SUBJECT: ISSUANCE OF AMENDMENT NO. 105 TO FACILITY OPERATING LICENSE NO.
DPR-35 - PILGRIM NUCLEAR POWER STATION (TAC #65491)

AMENDMENT TO FACILITY OPERATING LICENSE

Amendment No. 105
License No. DPR-35

RELATED TO LICENSE AMENDMENT FOR CYCLE 8 (RELOAD 7)

(4) Figures 3.11-1 through 3.11-7: MAPLHGR versus Planar Average Exposure Curves

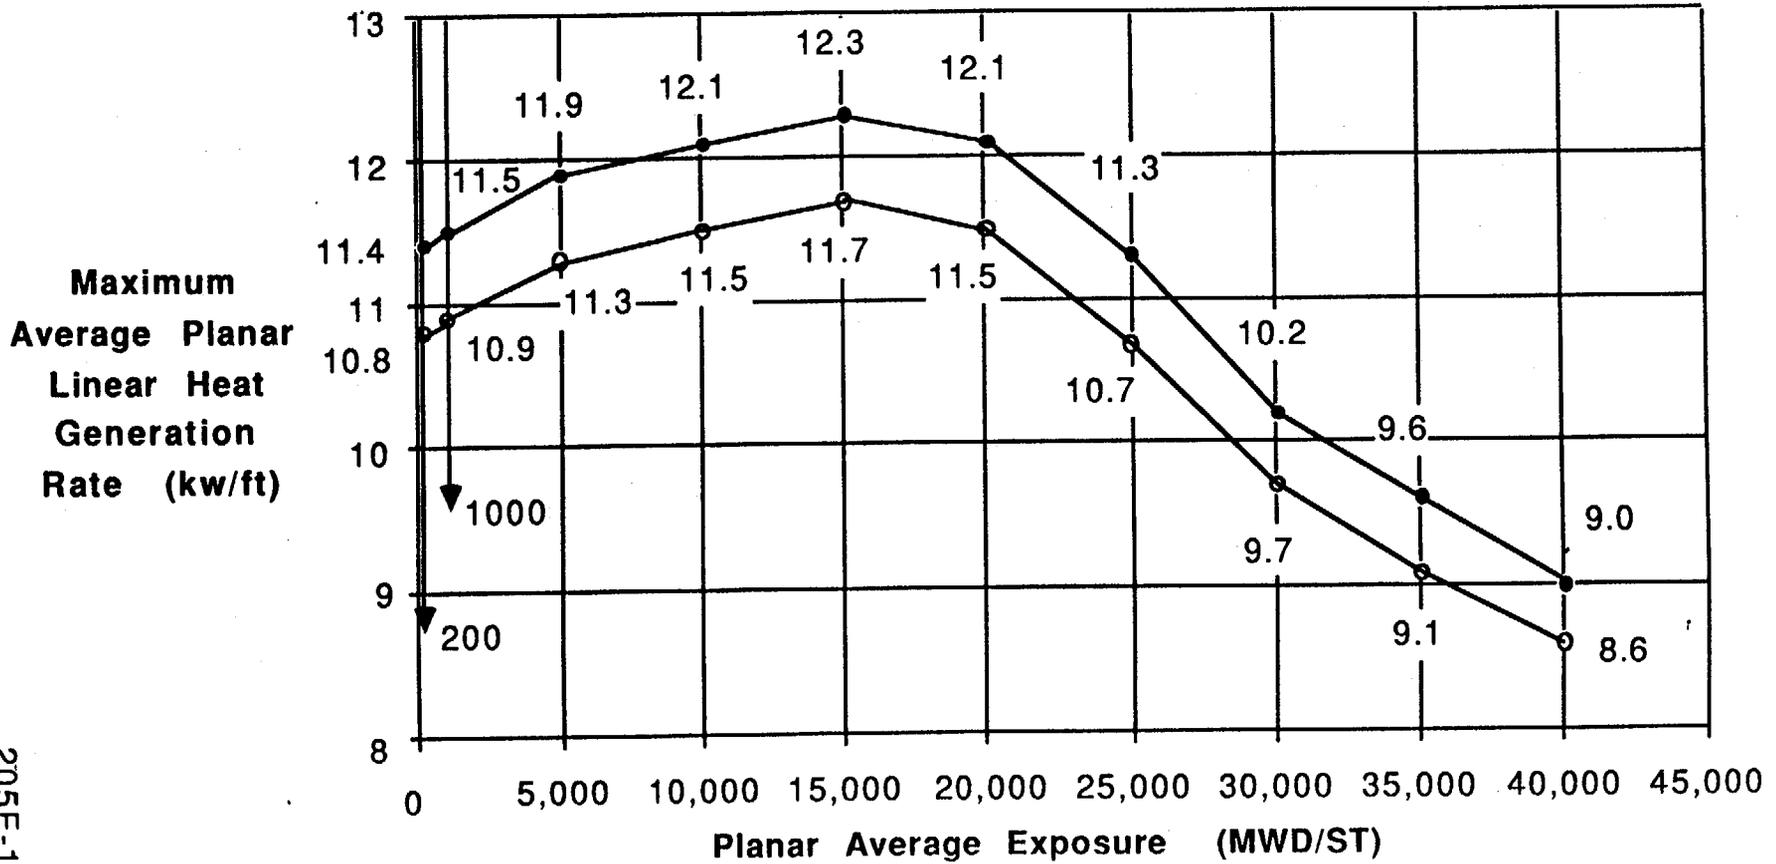
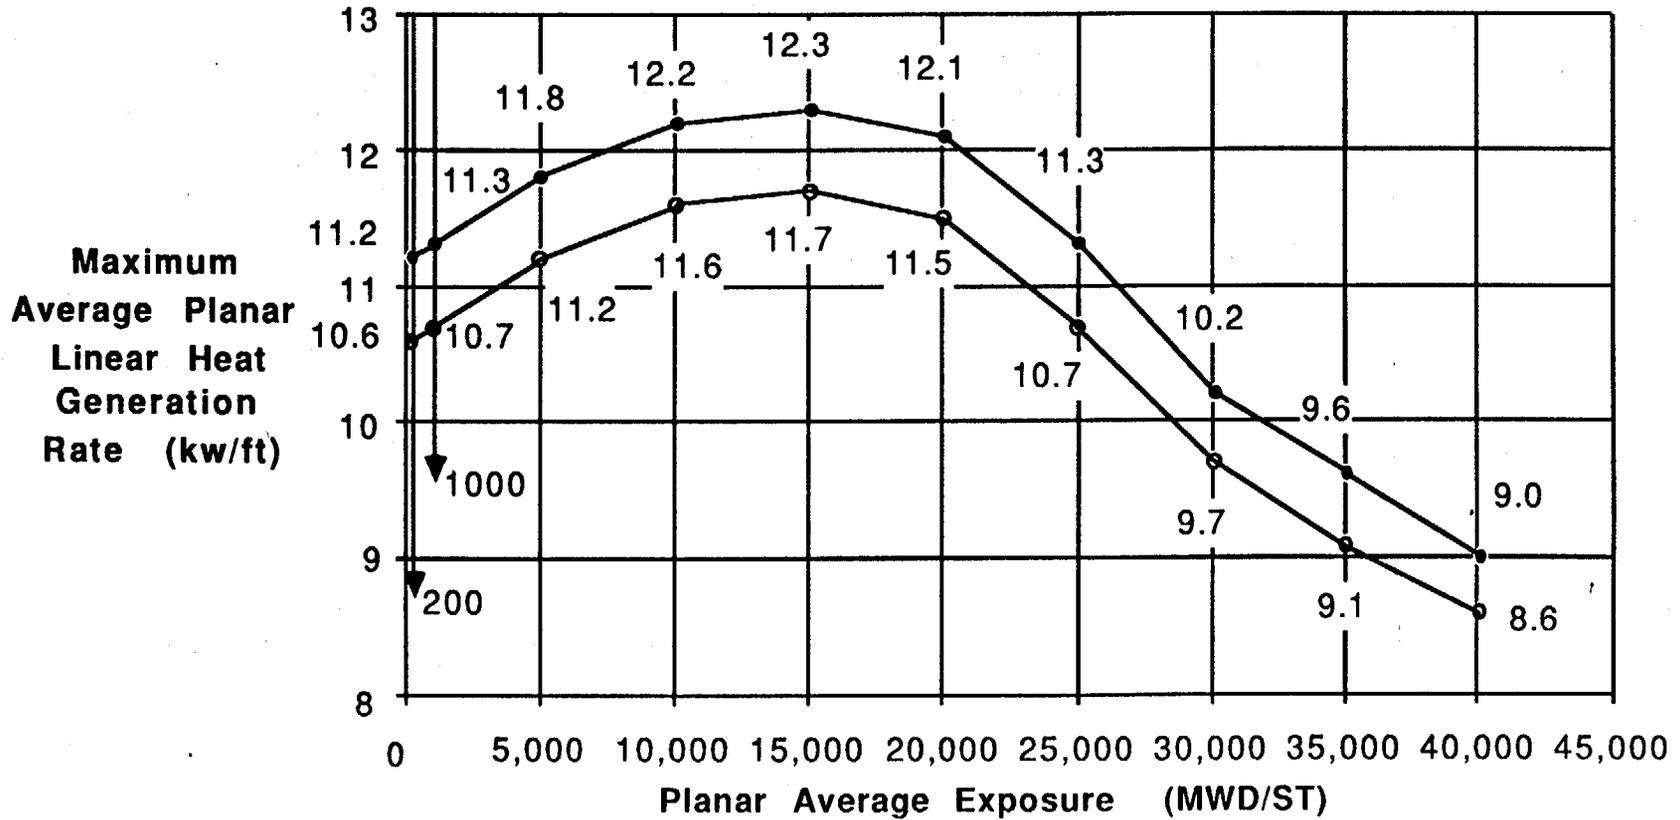
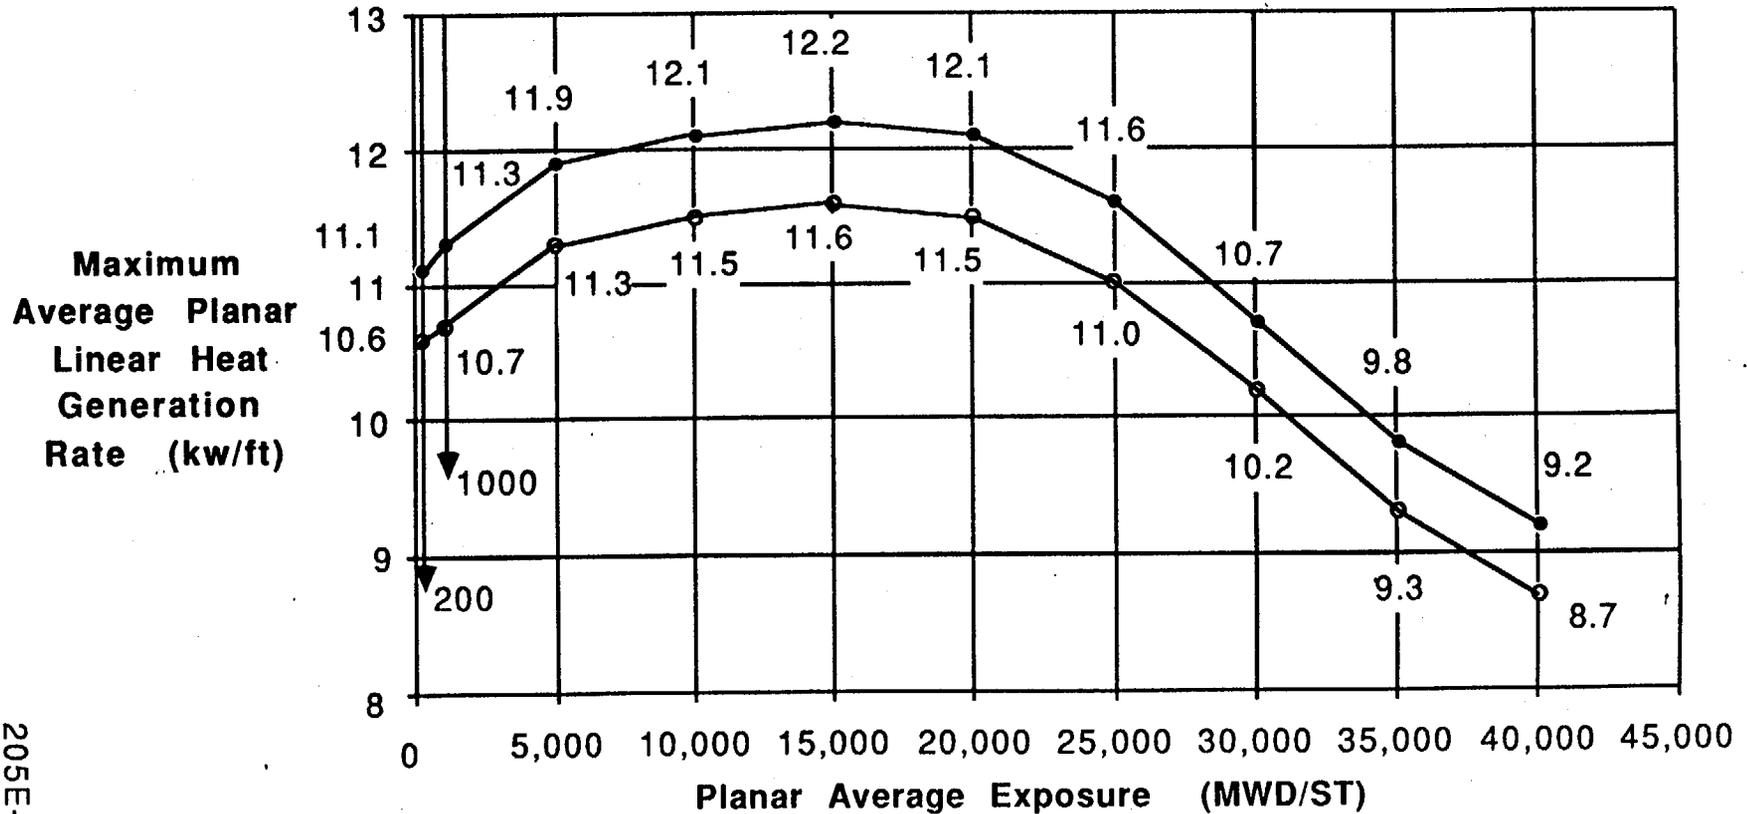
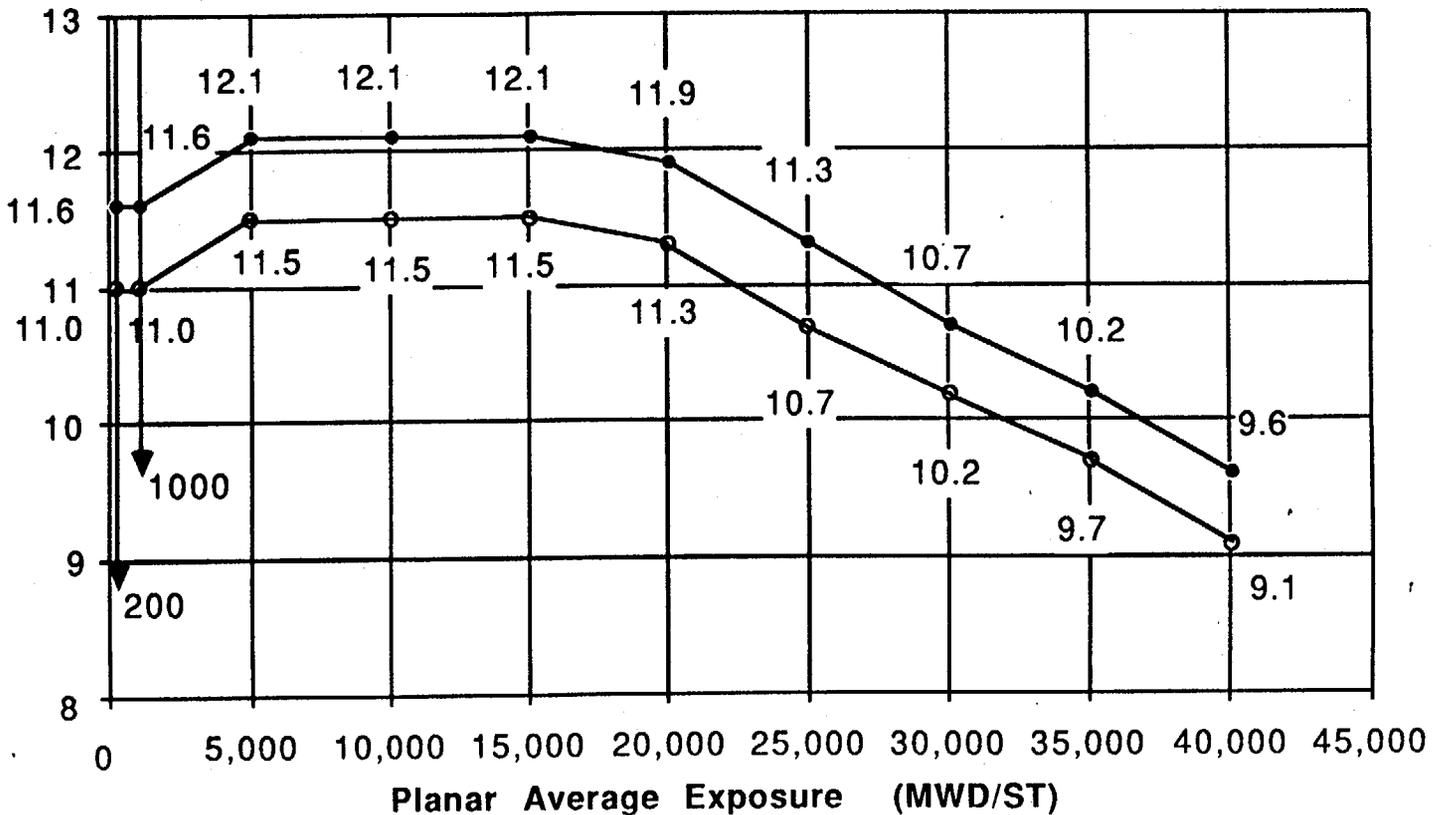
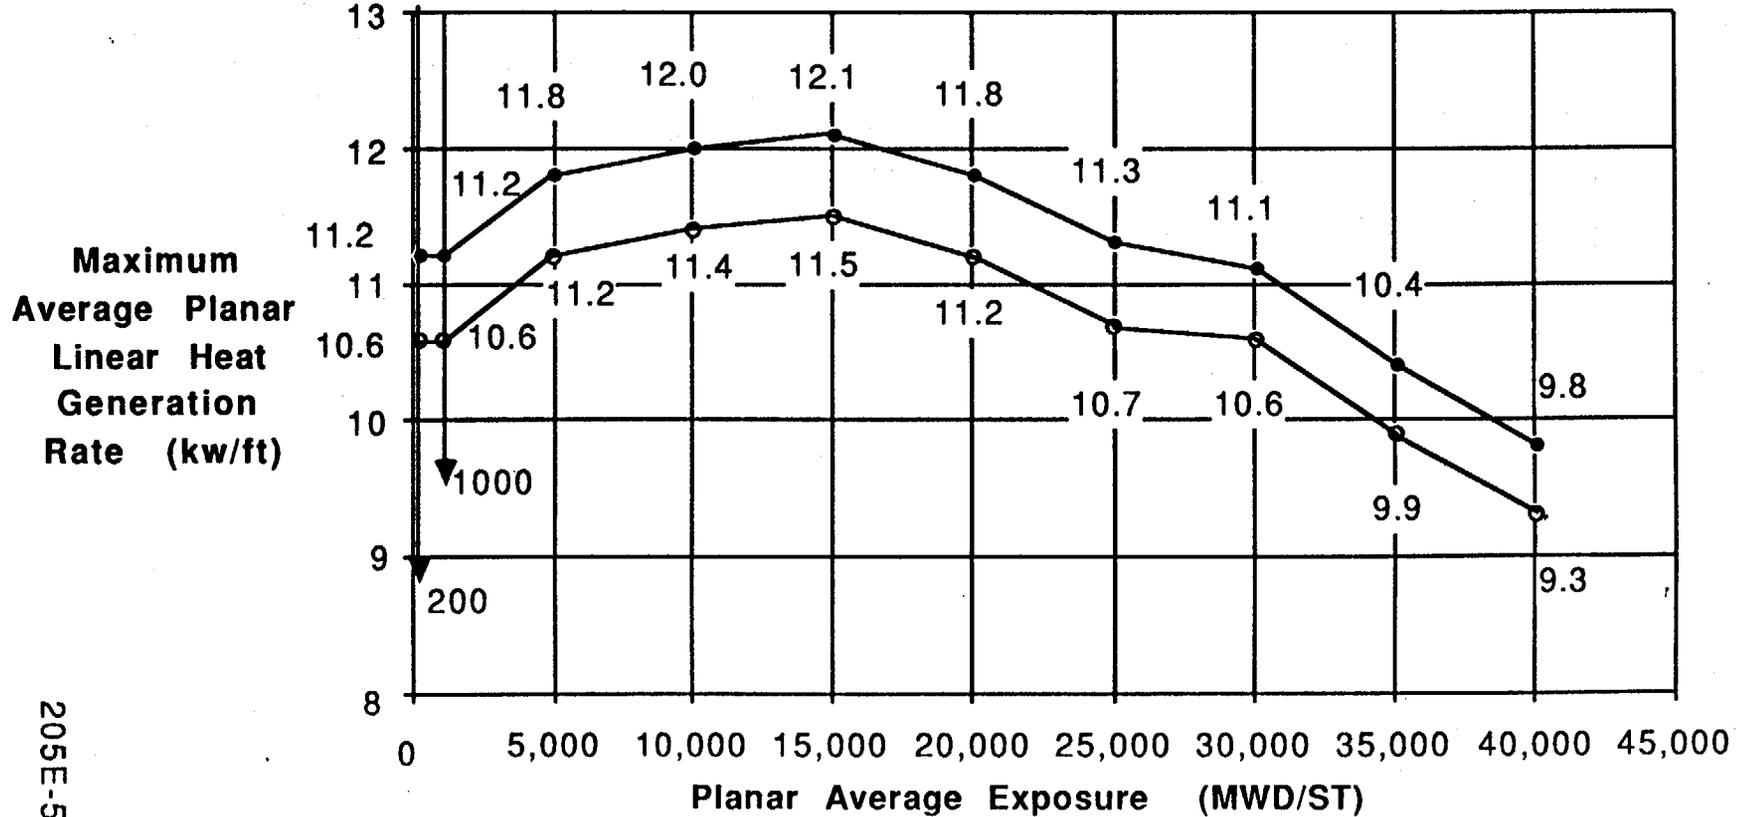
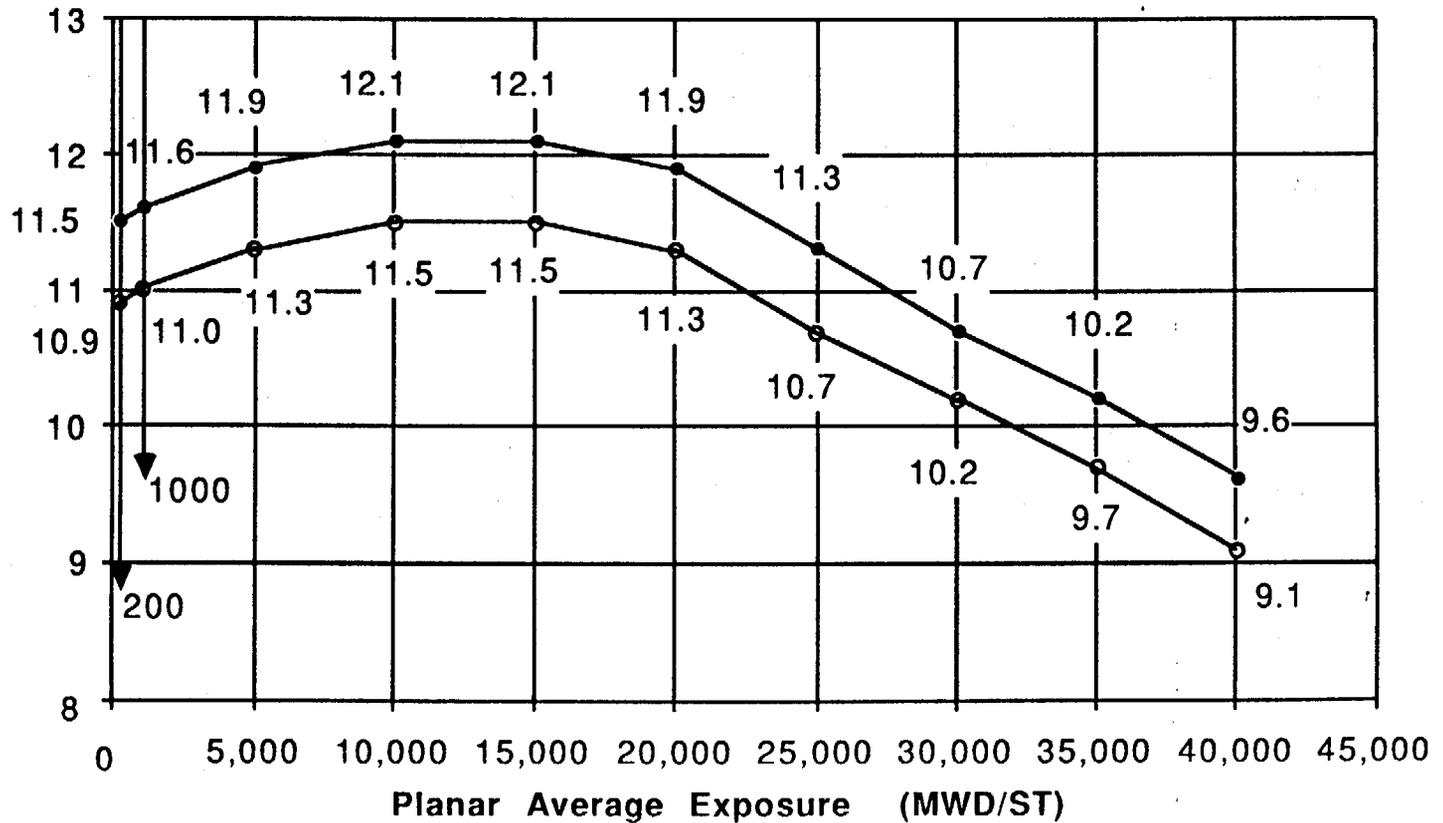
A new MAPLHGR curve is provided for the new fuel. A standard unit of fuel exposure, megawatt days per standard ton (MWD/ST), was established as uniform nomenclature. These changes are acceptable as discussed in Section 2.5.
